**ZONING AMENDMENT  
& SUBDIVISION STAFF REPORT****Date: June 5, 2008****APPLICANT NAME**

Kilson Uhn Subdivision

Southwest corner of Springhill Avenue and Hemley Avenue, extending to the East side of Ogden Avenue, 160± South of Springhill Avenue.

Rezoning from R-1, Single-Family Residential, and B-3, Community Business, to B-3, Community Business to allow retail sales.

# SITE PLAN

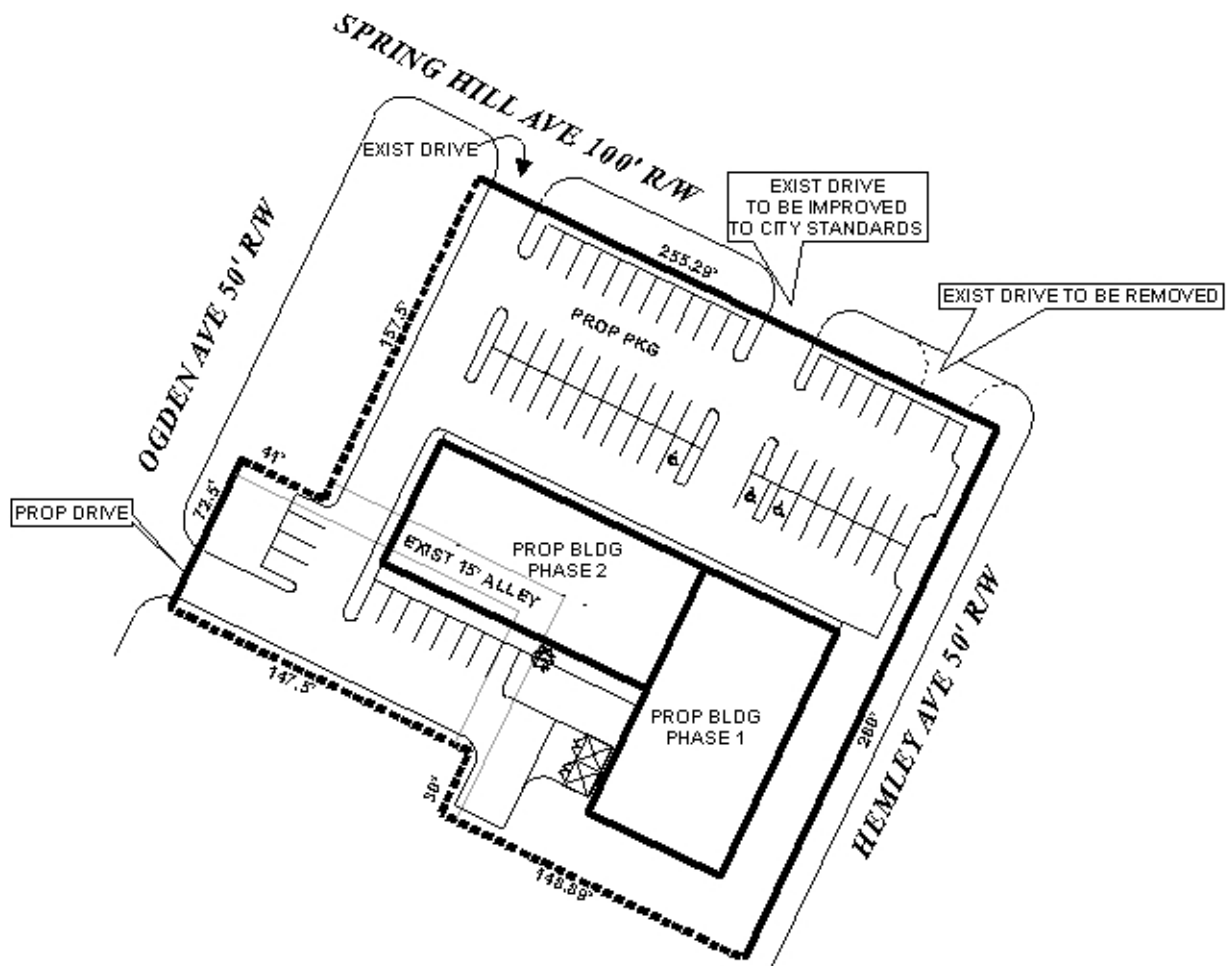
Driveway number, size, location, and design to be approved by Traffic Engineering and ALDOT and conform to AASHTO standards. Final approval for all driveways, proposed and existing will be given upon submittal of final plans. Remove or relocate driveway western most driveway because of its proximity to the intersection of Ogden Drive.

Spring Hill Avenue is a five-lane major street, with 22,000 cars per day on average (per 2006 data), and as such access management is a concern. There are currently 4 existing curb cuts onto Spring Hill Avenue and one onto Hemley Avenue. The applicant is proposing two curb-cuts onto Spring Hill Avenue and one curb cut onto Ogden Avenue, closing all other existing curb-cuts. A note should be placed on the final plat that states Lot 1 is limited to two curb cuts onto Spring Hill Avenue, one curb cut to Ogden Avenue with access denied to Hemley Avenue. In addition, the size, design and exact location to be approved by Traffic Engineering and conform to AASHTO standards.

The 25-foot minimum building setback is not depicted for proposed Lot 1, but would be required on the final plat, if approved. The 25-foot setback should also be depicted from the frontage on Ogden Avenue and Hemley Avenue.

- 1) Placement of a note on the final plat stating that Lot 1 is limited to two curb cuts onto Spring Hill Avenue with access denied to Ogden Avenue and Hemley Avenue. The size, design, and exact location are to be approved by Traffic Engineering and conform to AASHTO standards;

- 2) Revision of the plat to depict a 25' minimum building setback line on all street frontages;
- 3) Vacation of the 15' right-of-way for the unopened alley prior to signing of the final plat;
